UNITED STATES DEPARTMENT OF COMMERCE
National Oceanic and Atmospheric Administration
NATIONAL MARINE FISHERIES SERVICE
Southeast Regional Office
263 13th Avenue South
St. Petersburg, Florida 33701-5505
<http://sero.nmfs.noaa.gov>

Per your request received March 22, 2019, we reviewed Alternative 2-6d (Recommended Plan), Alternative 1-1, and additional alternatives that maintain higher weir and pool heights for the proposed fish passage at the New Savannah Bluff Lock and Dam (NSBLD) associated with the Savannah Harbor Expansion Project (SHEP). We believe that Alternative 2-6d (Recommended Plan) provides a higher likelihood of passing endangered Atlantic and shortnose sturgeon without delay than Alternative 1-1. We also believe other full-river-width fish passage structures, following the same overall design as Alternative 2-6d, would provide a higher likelihood of passing fishes without delay than Alternative 1-1.

Comments on Alternatives 2-6d (Recommended Plan)

Figure 1 – Alternative 2-6d (Recommended Plan) with Elevation¹

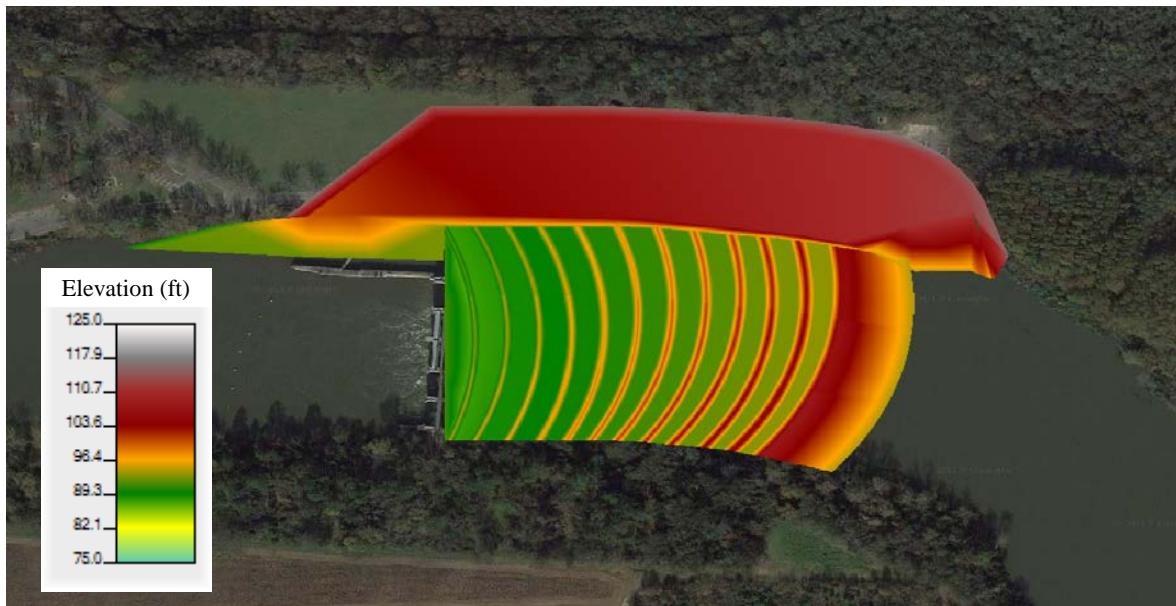
Alternative 2-6d is an in-channel fish passage design with a 500-foot-wide fixed crest weir at elevation 109 feet NGVD29 with a floodplain bench that maintains a pool height of 111 feet NGVD 29 at 5,000 cfs (Figure 1). Alternative 2-6d is an example of a full-river-width nature-like fishway (NLF).

A full-river-width NLF eliminates the potential for poor fishway entrance siting and false attraction.² A fishway spanning the entire width of the river makes entrance location irrelevant, minimizes attraction delay, and maximizes attraction efficiency^{3,4,5}. A full-river-width NLF also passes all river flows during non-flood conditions. This design ensures no false attraction occurs because all flows ultimately lead to the NLF structure.

The zone-of-passage refers to the contiguous area of sufficient lateral, longitudinal, and vertical extent in which adequate hydraulic and environmental conditions exist to provide a route of passage for fish through a stream reach.⁶ A full-river-width NLF ensures a continuum of hydraulics that provides a zone-of-passage across different river flow regimes. At low river flows, sturgeon will find a zone-of-passage through the deeper parts of the NLF while the shoreline zones will be too shallow for passage. At higher river flows, the deeper parts of the NLF may develop excessive turbulence and velocity, but the shoreline zones will become deep enough to provide a zone-of-passage. This design feature, and the hydraulic diversity it provides, ensures that regardless of species' swimming ability, fishes are more likely to find suitable routes of passage at a multitude of flow conditions.⁷

The downstream toe of the NLF in the Alternative 2-6d is approximately even with the location of the existing dam, which is well upstream from an existing gravel bar, likely used by sturgeon to spawn (“Spawning Area” in Figure 2). The distance away from the gravel bar reduces the likelihood Alternative 2-6d will adversely impact it via changes in fluvial geomorphic processes (e.g., scour) caused by the NLF.
